HISTORIC AND DESIGN REVIEW COMMISSION

HDRC CASE NO: 2018-451
ADDRESS: 607 E LOCUST
LEGAL DESCRIPTION: NCB 1735 BLK 14 LOT 3
ZONING: MF-33 H
CITY COUNCIL DIST.: 1
DISTRICT: Tobin Hill Historic District
APPLICANT: Jose Calzada/Architectura SA
OWNER: Rafael Saavedra Sada/Aster Development LLC
TYPE OF WORK: Construction of four, three story townhomes
APPLICATION RECEIVED: August 31, 2018
60-DAY REVIEW: October 30, 2018

**Historic and Design Review Commission
Design Review Committee
Report & Recommendation**

SURROUNDING BUILDING HEIGHTS

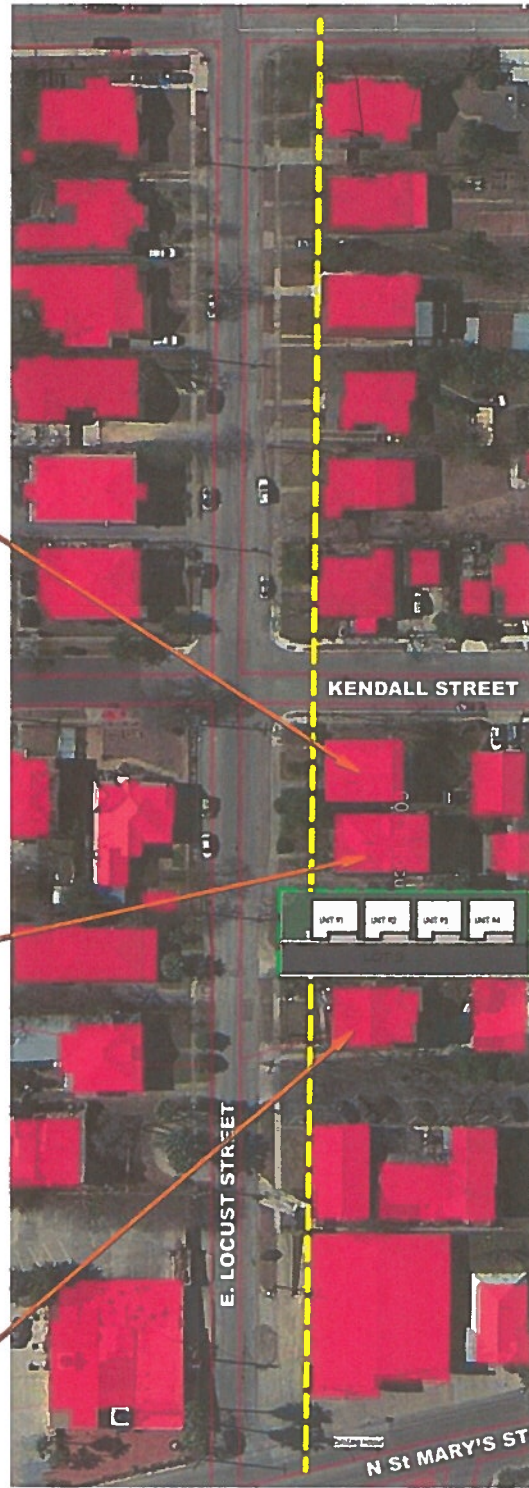
COMMENTS/CONCERNS: PROPOSED HEIGHT IS 38' (APPROXIMATELY).
ADJACENT 2-STORIES ARE APPROX. 31'-36'.
ACROSS THE STREET IS ALL 1-STORY HOMES.
ADJACENT FRONT SETBACK IS 25'; PROPOSED
SETBACK IS 19' (APPROXIMATELY).
HOUSES IMMEDIATELY ADJACENT ARE WOOD.

OVERALL HEIGHT IS CLOSE TO ADJACENT BUT STILL ~5' TALLER. PLATE HEIGHTS?

- ii. That the applicant explores 2.5-story massing options to respond to the dominant historic massing context of the neighborhood.
- iii. That the applicant incorporates roof forms that are more consistent with the typologies found in the Tobin Hill Historic District.

SCHEMATIC DESIGN

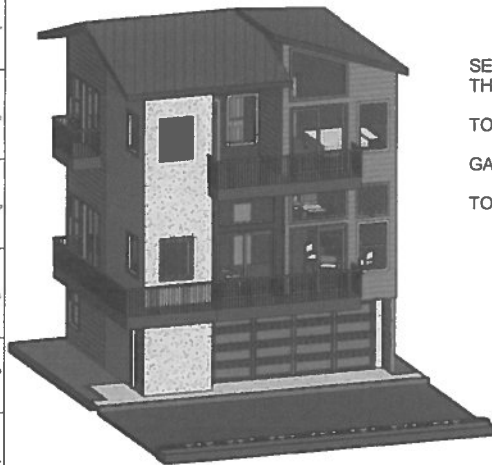
- g. **SCALE & MASS** – The applicant has proposed four detached 3-story units. One will be located along the street frontage of E Locust, and three will be located in the rear of the property. Per the submitted elevations and verbal information from the applicant, the ridgeline of the units is approximately 38'. The floor heights are 12 feet, 8 feet, and 10 feet for the first floor, second floor, and third floor, respectively. Guideline 2.A.i stipulates that the height and scale of new construction should be consistent with nearby historic buildings and should not exceed that of the majority of historic buildings by more than one-story. Per the submitted elevations, the applicant has indicated that the 2-story historic structures directly to the east and west are approximately 30-31 feet. The proposed massing is not consistent with the historic examples found on the block. Staff does not find the proposal consistent with the Guidelines.

- i. ROOF FORM – The applicant has proposed steeply sloping roof forms. As proposed, the overall roof forms are not consistent with precedents in the district or the Historic Design Guidelines.

- j. WINDOW & DOOR OPENINGS – According to the Historic Design Guidelines for New Construction, window openings with a similar proportion of wall to window, as compared to nearby historic facades, should be incorporated. Similarity is defined by windows that are no larger than 25% in size and vary no more than 10% in height to width ratio from adjacent historic facades. The applicant has proposed several window and door openings that generally feature sizes that are found on historic structures. However, the rear elevation of the front units and the side elevation of the rear unit contain small, fixed square windows that are not consistent with the OHP Window Policy Document or historic fenestration precedents in the district. Additionally, per the plans for the front units, the east side elevation contains no fenestration at all. This blank wall on the west front unit will face towards McCullough Ave and will be directly visible from the public right-of-way. This blank wall space exceeds the continuous wall space recommendations in the Guidelines. With regards to materiality, the applicant has proposed to install Milgard vinyl doors and windows. Per the submission, the windows will feature either flat, sculptured, or simulated divided lites on the top sash of the double hung windows. According to the OHP Window Policy Document, wood windows are most appropriate. Windows should also maintain traditional dimensions and profiles, and false dividing lites are not encouraged. Each window should be inset at least two (2) inches within walls to ensure that a proper façade depth is maintained. All windows should feature traditional appearance and feature traditional trim and sill details. As submitted, several of the proposed window sizes, configuration, profile, and materiality are inconsistent with the Guidelines.
